REMARKS

Serial Number 10/600,440

AMENDMENTS TO DRAWINGS

FIG. 1

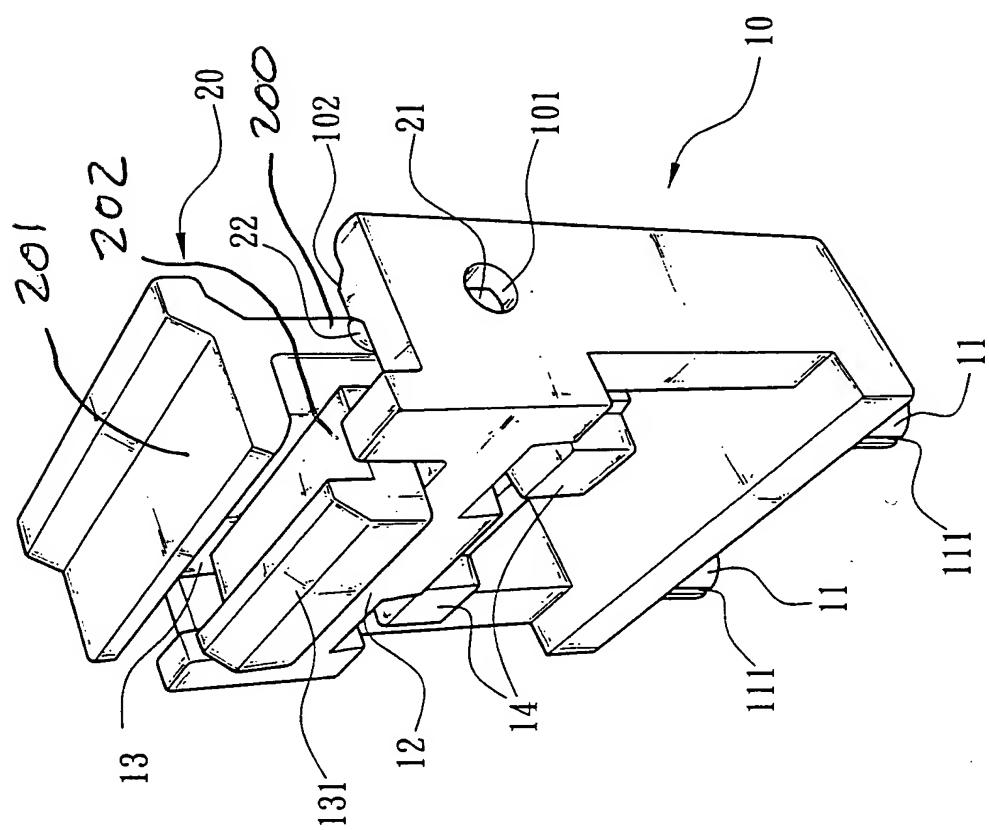
In order to provide proper antecedence for the added claim language, the drawings have been amended to include reference numbers for the main, middle, and top plates of the pivotal carrier, and the paragraph bridging pages 4 and 5 of the original specification has been amended accordingly. Again, the amendments to the drawings and specification are formal in nature, involving the addition of reference numerals and the naming of clearly shown but previously unnamed elements, and therefore the amendments to the drawings and specification also do not constitute “**new matter**.”

Please add reference numerals 200, 201, and 202 to Figs. 1-3, as indicated in the attached REPLACEMENT SHEETS, and as marked in red on the attached ANNOTATED SHEETS SHOWING THE CHANGES.

FIG. 2

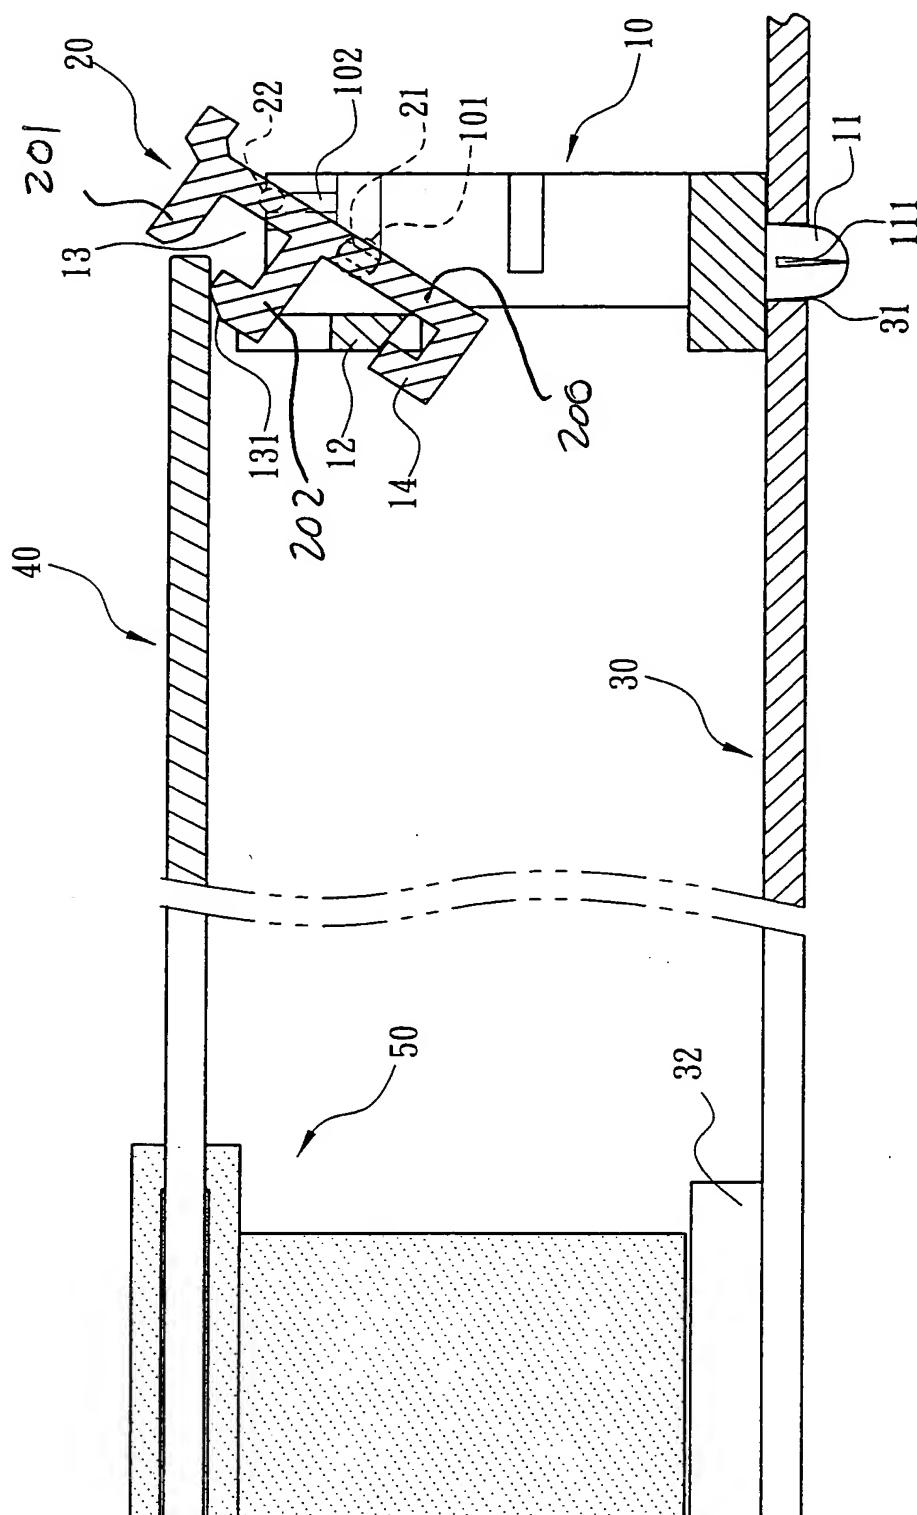
As is best illustrated in Figs. 2 and 3 of the present application, the claimed invention is arranged so that when a card held by a dummy adapter 50 is installed on the motherboard, by vertically inserting the dummy adapter into an available card slot, *the edge of the card will press down on slanted surface 131 and cause carrier 20 to pivot* about pivot 21 so as to capture the edge of the card in the trough formed by plates 201 and 202. There is no need for the user to manually snap the carrier onto the card as in the Hileman patent. On the other hand, because of the arrangement of the pivot hole 58 of Hileman at the front and bottom of the carrier, downward movement of a card against one of the arms of Hileman will have the initial effect of pivoting the arm away from the card securing position, thus necessitating the manual manipulation of the grips.
